USSN 10/042,237
Art Unit 2644

Amendments to the Drawings

App. No. 10/092,237
Art Unit: 2644**FIG. 3**

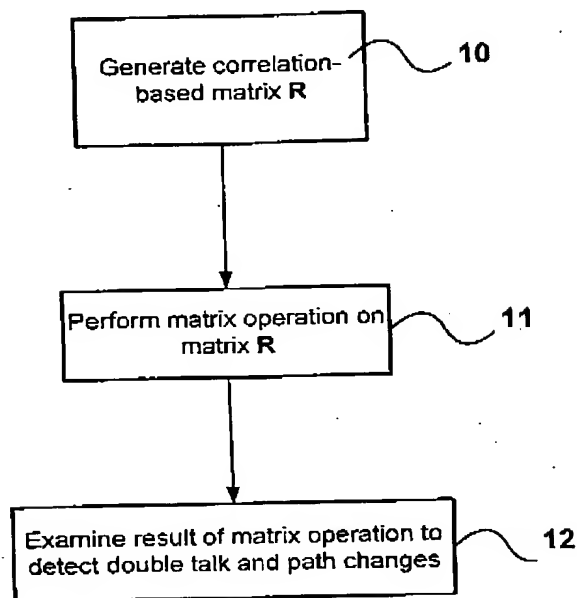
Permission is respectfully requested to replace the sheet of drawings containing Figure 3 on file with the replacement sheet submitted herewith. The newly added subject matter has been deleted in box 12 and replaced by wording taken from the specification.
